Additional information regarding resurfacing and site improvement application

This note includes additional information requested by the reviewing architects questions below:

1.1 Plan showing location of gullies

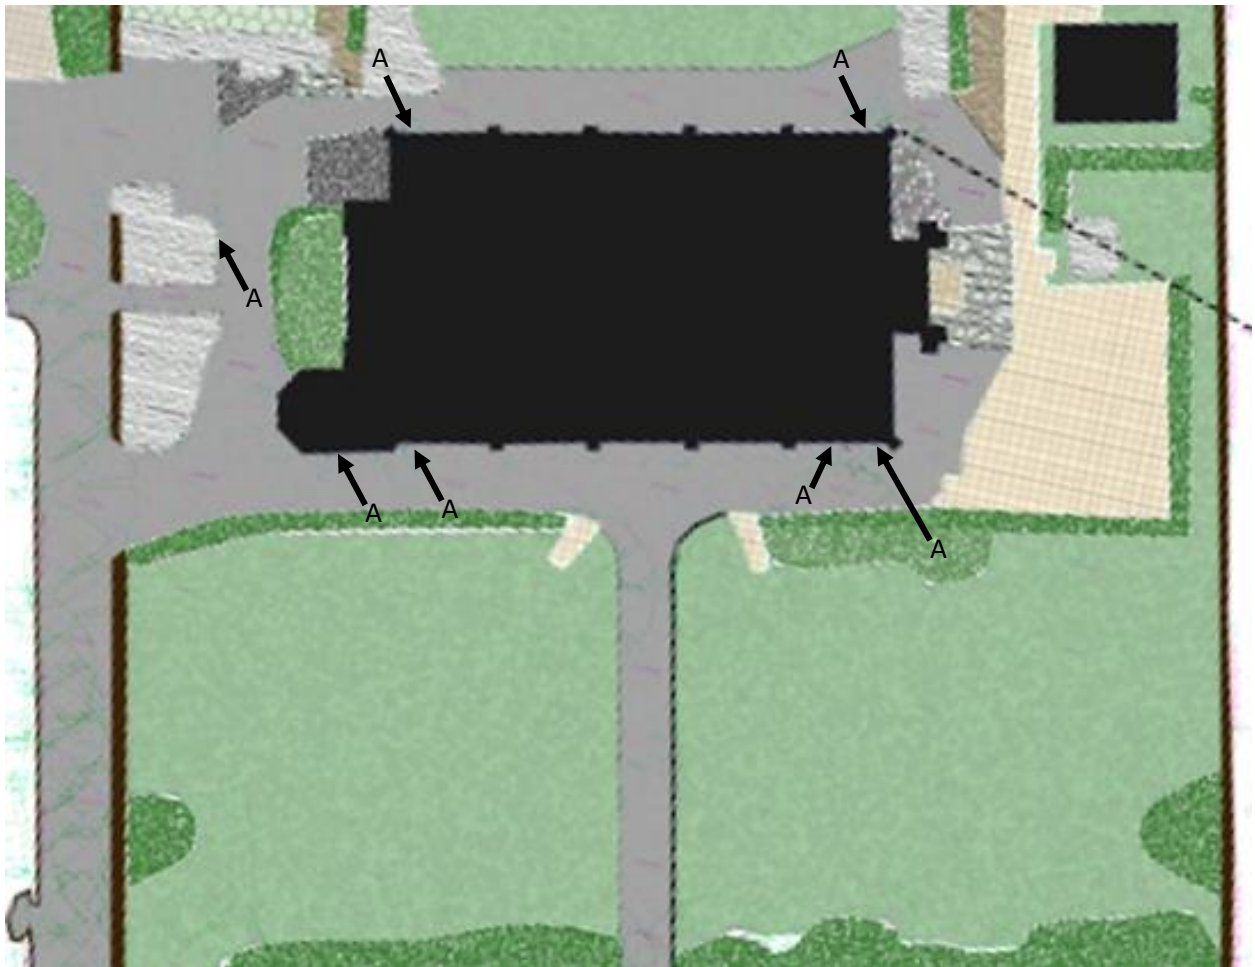
1) The specification must detail how the drain gullies will be reset

2) Drawing 3B should include details of drainage points as described above

A = Location of gully

1.2 Specification for resetting of drainage gullies

The current gullies are all trapped drainage units. These will be removed as the resurfacing works are prepared. If possible they will be retained for reuse. If this is not possible, they will be replaced with suitable new trapped units.

The surrounding area will be excavated to reveal connecting pipework, allowing inspection and required adjustments to the connecting underground pipework.

The set-aside, or new gullies units, will be installed, connected to the existing pipework and set at the required level. They will be bedded in with suitable backfill to ensure they are stable and to prevent future distortion. The wearing course, as specified in the technical specification, will be blended in to ensure free flow of surface water from the roadways into the into the gullies.

2. Cycle parking details

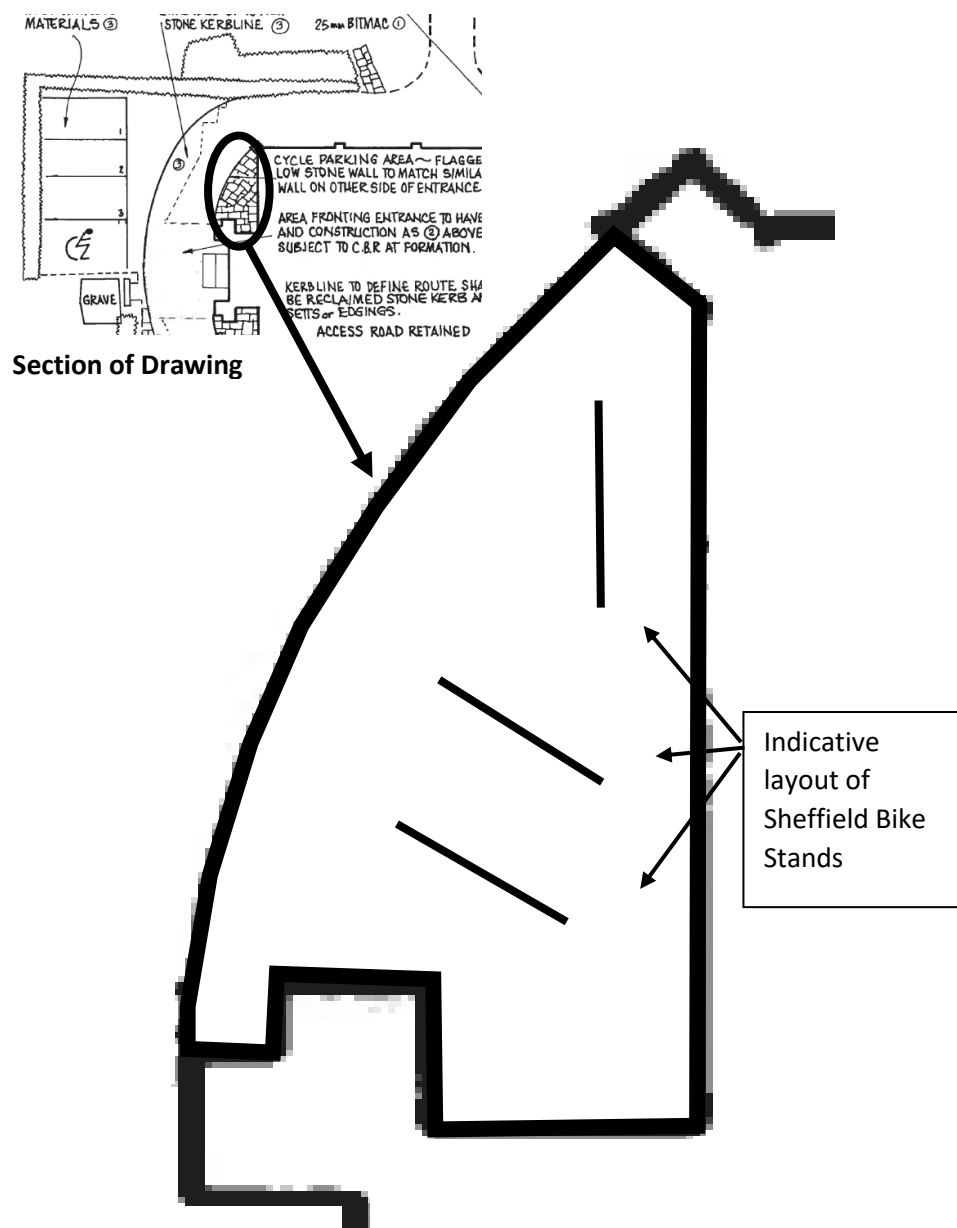
3) There is no detail of the cycle racks (I didn't resend all the information from last month, so I have advised that we have seen this already, and have said I will send this on)

2.1 Specification

Cycle parking area at the northwest corner of the church to be created.

- Area will be flagged and delineated with a low (300mm stone wall) using stones reused from the existing parking area to match the similar wall on the other side of the entrance.
- 700mm high Sheffield stands, made from 50mm diameter galvanised tube, secured through a base plate with tamper proof bolts will be installed.

2.2 Illustration of bike stand layout

The sketch below shows the indicative layout of the cycle stands.
